UNITED STATES
DEPARTMENT OF THE INTERIOR
BUREAU OF LAND MANAGEMENTFORM APPROVED
OMB NO. 1004-0137
Expires: January 31, 2018**SUNDRY NOTICES AND REPORTS ON WELLS**
*Do not use this form for proposals to drill or to re-enter an abandoned well. Use form 3160-3 (APD) for such proposals.*5. Lease Serial No.
NMSF078106

GALLEGOS CANYON UNIT 20

Plug And Abandonment Procedure

CONDITIONS OF APPROVAL

Wellbore Diagram

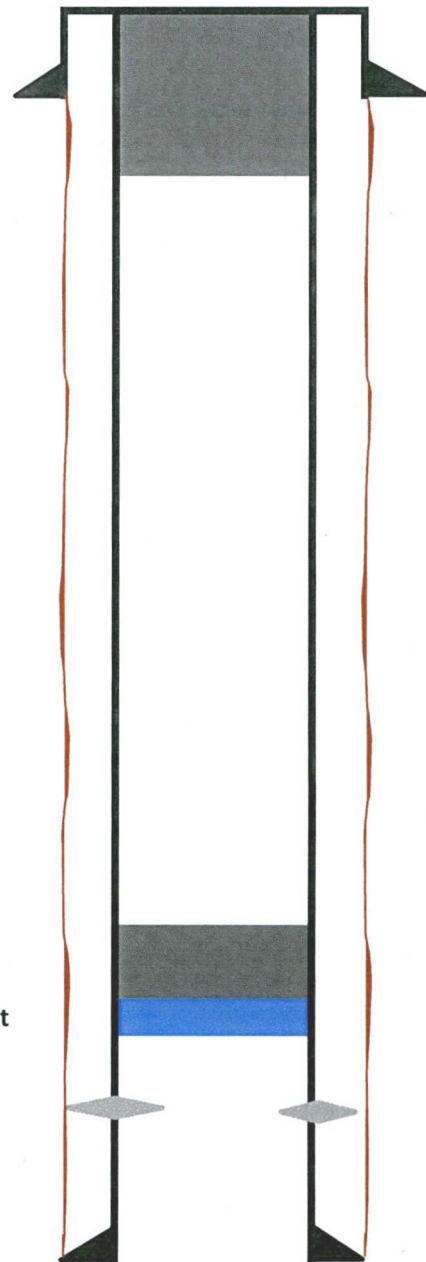
1. Plugging operations authorized are subject to the attached "General Requirements for Permanent Abandonment of Wells on Federal and Indian Lease."
2. Farmington Office is to be notified at least 24 hours before the plugging operations commence (505) 564-7750.
3. The following modifications to your plugging program are to be made:
 - a. Extend Plug #1 (1348-1067) ft. To cover the top of the Fruitland formation. BLM picks top of the Fruitland at 1117 ft.

Operator will run a CBL to verify cement top. Submit the electronic copy of the log for verification to the following addresses: jwsavage@blm.gov Brandon.Powell@state.nm.us

You are also required to place cement excesses per 4.2 and 4.4 of the attached General Requirements.
